#### Working Party on Lighting and Light-Signalling

## **Proposal for Supplement 7 to Regulation No. 99 (Gas-discharge light sources)**

### **Submitted by the expert from the International Electrotechnical Commission\***

Figure 1 - Category D5S - Cap PK32d-[7]

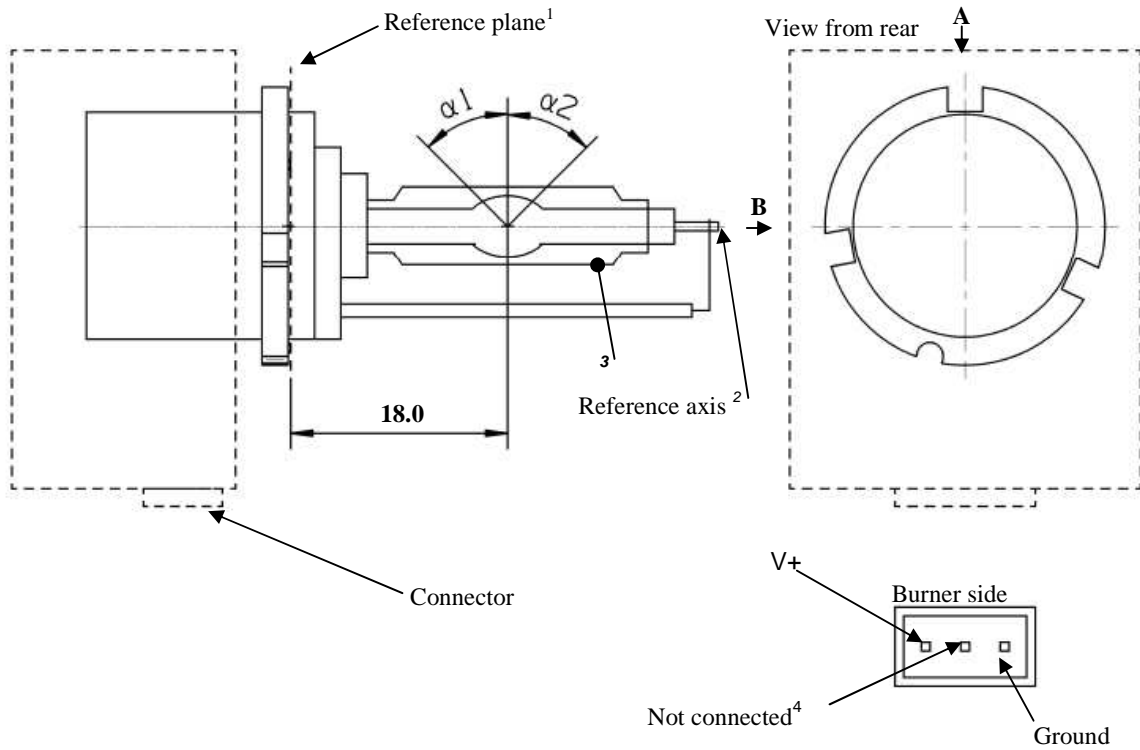
Insert new sheets D5S/1 to 5 and D6S/1 to 5, after DxS/6, to read:

- <sup>1</sup> The reference plane is defined by the positions on the surface of the holder on which the three supporting bosses of the cap ring will rest.
- <sup>2</sup> See sheet D5S/2.
- <sup>3</sup> When measured at a distance of 18.0 mm from the reference plane and with respect to the mid-point of the inner bulb, the outer bulb shall have an eccentricity of 1 mm max.
- <sup>4</sup> Optional Pin.

Figure 2  
 Definition of reference axis<sup>1</sup>  
 The cap shall be pushed in this direction

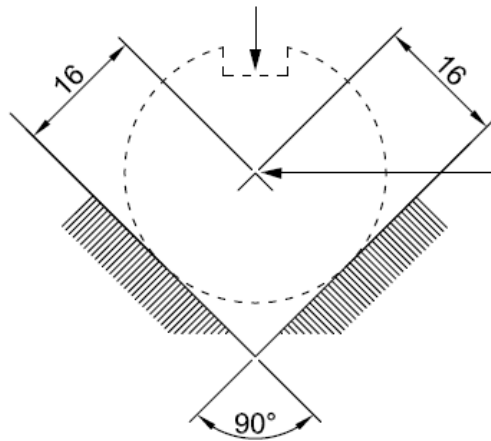
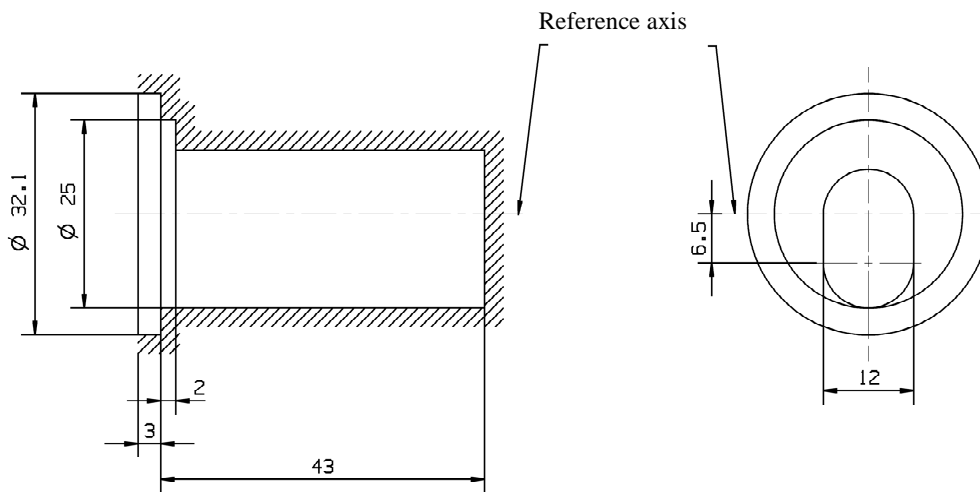
- <sup>1</sup> The reference axis is perpendicular to the reference plane and crosses the intersection of the two parallel lines as indicated in figure 2.
- <sup>2</sup> Glass bulb and supports shall not exceed the envelope, as indicated in figure 3. The envelope is concentric with the reference axis.

Sheet D5S/3

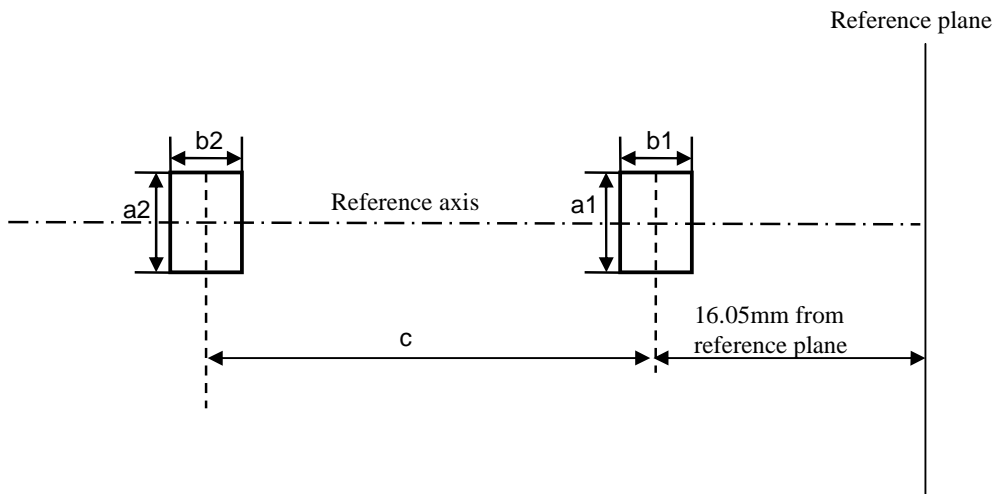
<i>Dimensions</i>		<i>Production light sources</i>	<i>Standard light sources</i>	
Position of the electrodes		Sheet D5S/4		
Position and form of the arc		Sheet D5S/5		
$\alpha 1, \alpha 2$ <sup>1</sup>		55° min.	55° min.	
D5S: Cap PK32d-[7] in accordance with IEC Publication 60061 (sheet 7004-111-[4])				
ELECTRICAL AND PHOTOMETRIC CHARACTERISTICS				
Rated voltage	V	12 / 24	12 / 24	
Rated wattage	W	25	25	
Test voltage	V	13,2 / 28	13,2 / 28	
Objective lamp wattage <sup>2</sup>	W	31 max.	31 max.	
Chromaticity coordinates	Objective	x = 0.375	y = 0.375	
	Tolerance area <sup>3</sup>	Boundaries	x = 0.345	y = 0.150 + 0.640 x
			x = 0.405	y = 0.050 + 0.750 x
		Intersection points	x = 0.345	y = 0.371
			x = 0.405	y = 0.409
			x = 0.405	y = 0.354
x = 0.345	y = 0.309			
Objective Luminous flux	lm	2000 ± 300	2000 ± 100	
Hot-restrike switch-off time	s	10	10

<sup>1</sup> The part of the bulb within the angles  $\alpha 1$  and  $\alpha 2$  shall be the light emitting part. This part shall be as homogeneous in form as possible and shall be optically distortion free. This applies to the whole bulb circumference within the angles  $\alpha 1$  and  $\alpha 2$ .

Position of the electrodes

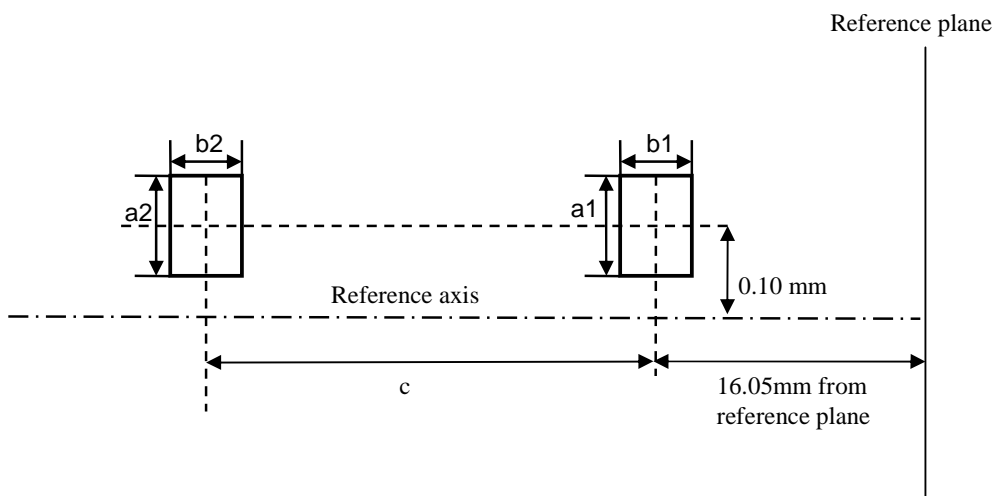
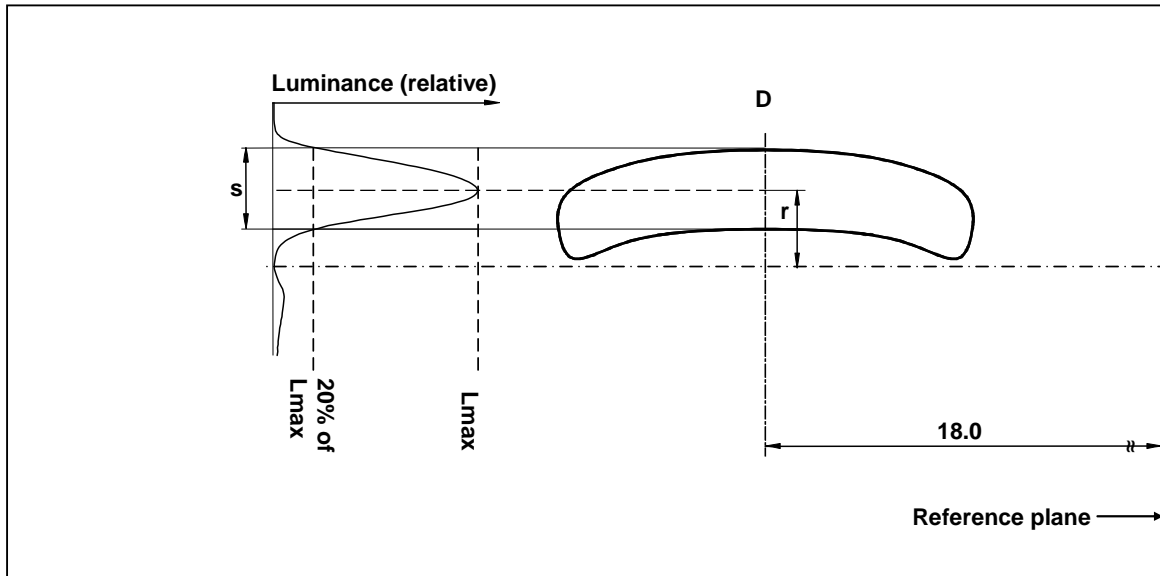
This test is used to determine whether the electrodes are correctly positioned relative to the reference axis and the reference plane.

Dimension in mm	Production light sources	Standard light sources
a1	0.30	0.20
a2	0.50	0.25
b1	0.30	0.15
b2	0.60	0.30
c	3.90	3.90

The arc attachment point to the electrode nearest to the reference plane shall be positioned in the area defined by a1 and b1. The arc attachment point to the electrode furthest from the reference plane shall be positioned in the area defined by a2 and b2.

Figure 1  
Category D6S - Cap P32d-1

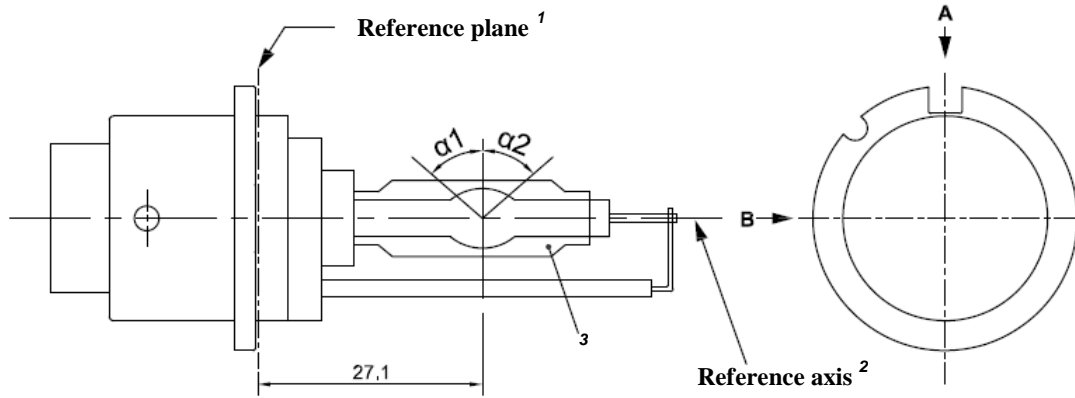
- <sup>1</sup> The reference plane is defined by the positions on the surface of the holder on which the three supporting bosses of the cap ring will rest.
- <sup>2</sup> See sheet D6S/2.
- <sup>3</sup> When measured at a distance of 27.1 mm from the reference plane and with respect to the mid-point of the inner bulb, the outer bulb shall have an eccentricity of 1 mm max.

Sheet D6S/2

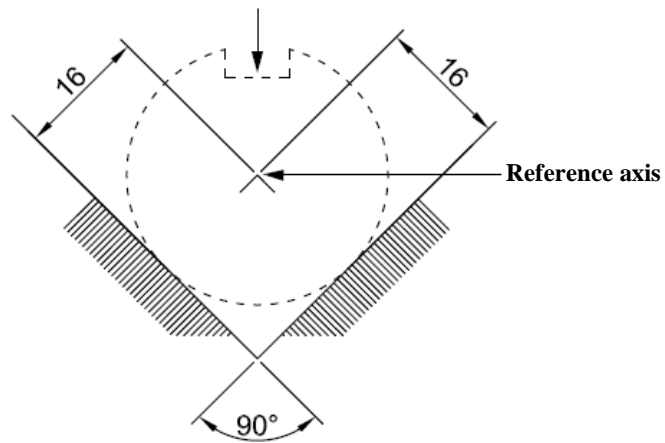
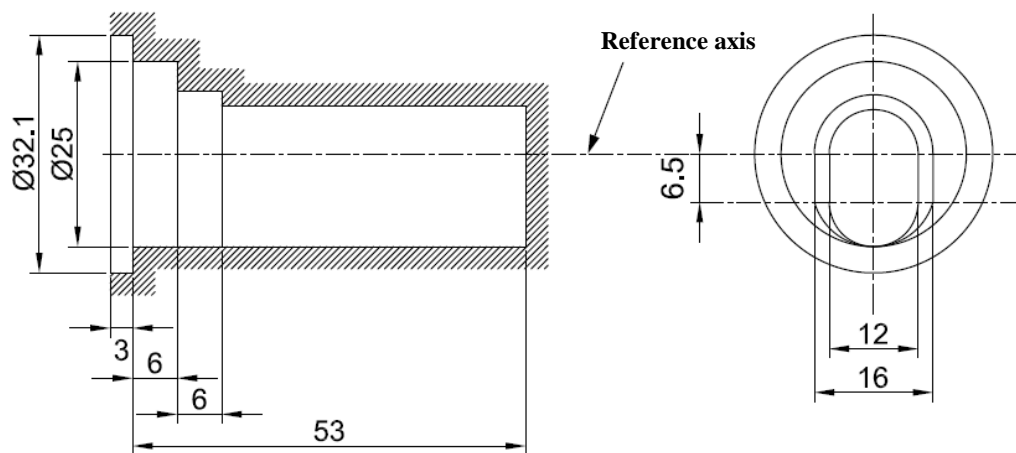
- <sup>1</sup> The reference axis is perpendicular to the reference plane and crosses the intersection of the two parallel lines as indicated in figure 2.
- <sup>2</sup> Glass bulb and supports shall not exceed the envelope, as indicated in figure 3. The envelope is concentric with the reference axis.

Sheet D6S/3

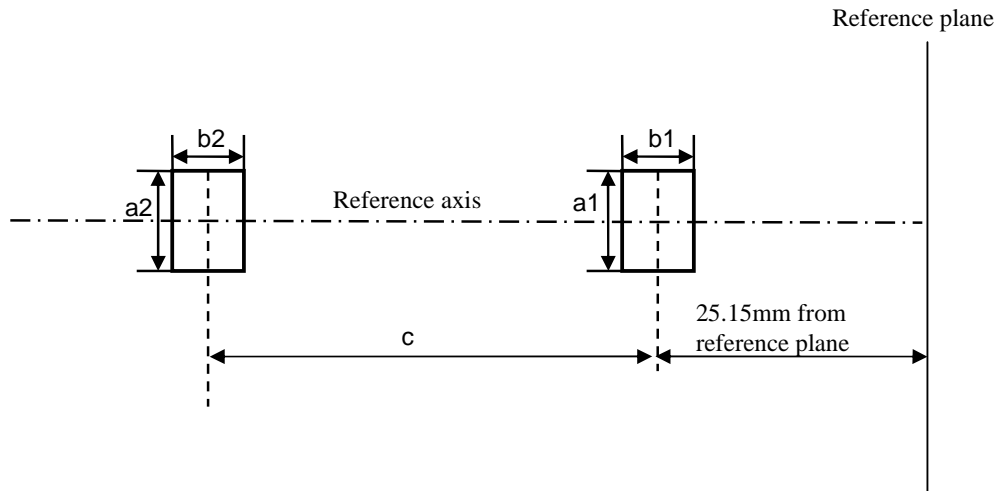
<i>Dimensions</i>		<i>Production light sources</i>	<i>Standard light sources</i>
Position of the electrodes		Sheet D6S/4	
Position and form of the arc		Sheet D6S/5	
$\alpha_1, \alpha_2$		55° min.	55° min.
D6S: Cap P32d-1 in accordance with IEC Publication 60061 (sheet 7004-111-[4])			
ELECTRICAL AND PHOTOMETRIC CHARACTERISTICS			
Rated voltage of the ballast	V	12 <sup>2</sup>	12
Rated wattage	W	25	25
Test voltage	V	13.2	13.2
Objective lamp voltage	V	42 ± 9	42 ± 4
Objective lamp wattage	W	25 ± 3	25 ± 0.5
Objective Luminous flux	lm	2000 ± 300	2000 ± 100
Chromaticity coordinates	Objective	x = 0.375	y = 0.375
	Tolerance area <sup>3</sup>	Boundaries	x = 0.345      y = 0.150 + 0.640 x
			x = 0.405      y = 0.050 + 0.750 x
		Intersection points	x = 0.345      y = 0.371
			x = 0.405      y = 0.409
Hot-restrike switch-off time	s	10	10

<sup>1</sup> The part of the bulb within the angles  $\alpha_1$  and  $\alpha_2$  shall be the light emitting part. This part shall be as homogeneous in form as possible and shall be optically distortion free. This applies to the whole bulb circumference within the angles  $\alpha_1$  and  $\alpha_2$ .

<sup>2</sup> Application voltages of ballasts may differ from 12 V.

**Sheet D6S/4**

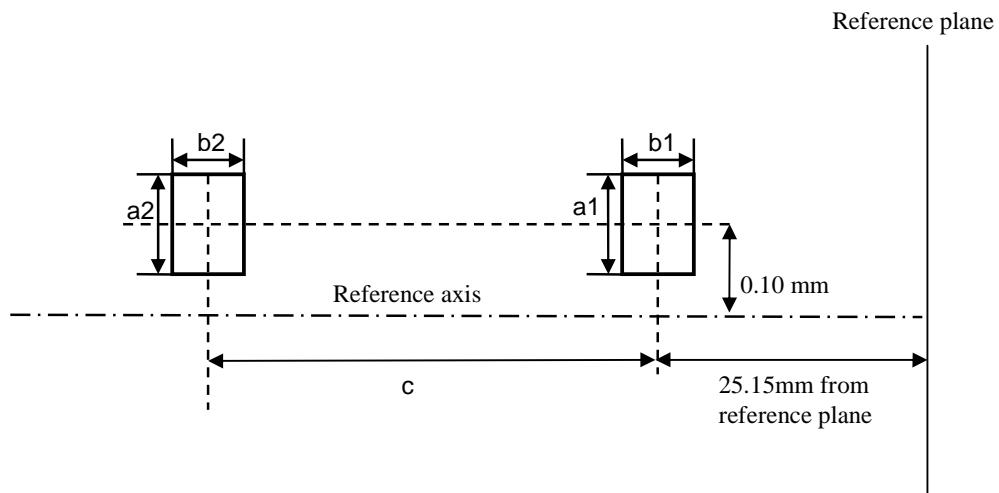
This test is used to determine whether the electrodes are correctly positioned relative to the reference axis and the reference plane.

Dimension in mm	Production light sources	Standard light sources
a1	0.30	0.20
a2	0.50	0.25
b1	0.30	0.15
b2	0.60	0.30
c	3.90	3.90

The arc attachment point to the electrode nearest to the reference plane shall be positioned in the area defined by a1 and b1. The arc attachment point to the electrode furthest from the reference plane shall be positioned in the area defined by a2 and b2.

Position and form of the arc

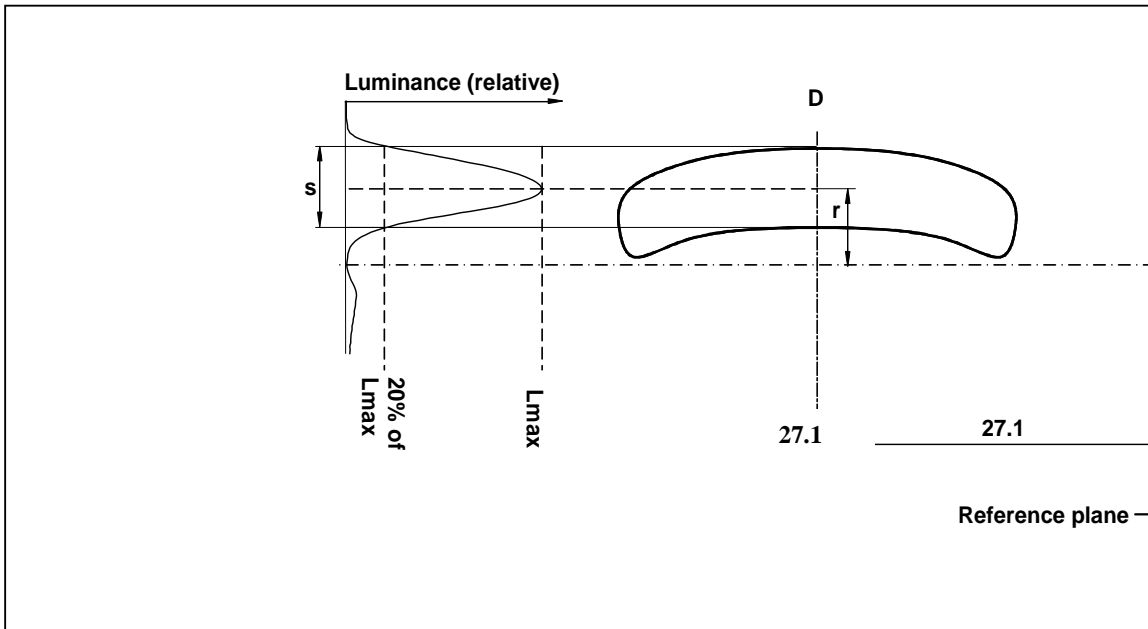
This test is used to determine the form of the arc and its position relative to the reference axis and the reference plane by measuring its bending and diffusion in the cross section at a distance 27.1 mm from the reference plane.

When measuring the relative luminance distribution in the central cross section as indicated in the drawing above, the maximum value shall be located within the distance r from the reference axis. The point of 20 per cent of the maximum value shall be within s.

<i>Dimension in mm</i>	<i>Production light sources</i>	<i>Standard light sources</i>
r (arc bending)	0.50 +/-0.25	0.50 +/-0.15
s (arc diffusion)	0.70 +/-0.25	0.70 +/-0.15
